Amendment to the Drawings:

REMARKS/ARGUMENTS

FIG. 2

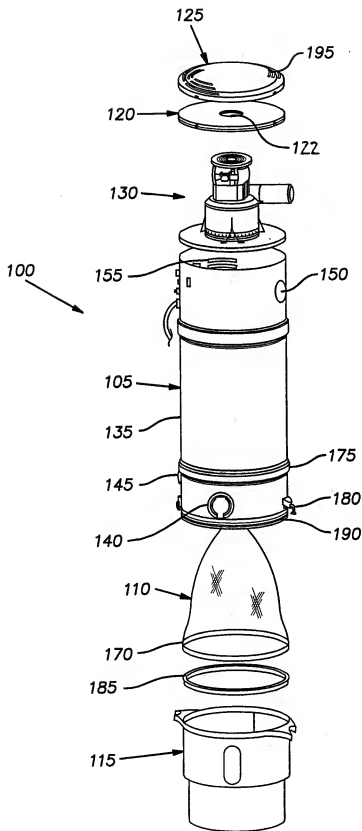
An appendix beginning on page 18 of this paper includes replacement sheets 2/5 and 3/5. These replacement sheets include changes to FIGS. 2-4. More specifically, previous reference number "185" in the upper portion of FIG. 2 has been changed to "122" to provide consistency with the specification as amended by the present amendment. Reference number "186" has been added to FIG. 3 and reference number "312" has been added to FIG. 4. These reference numbers also provide consistency with the specification as amended by the present amendment. No new matter is believed to be involved and therefore entry of the replacement sheets is respectfully requested.
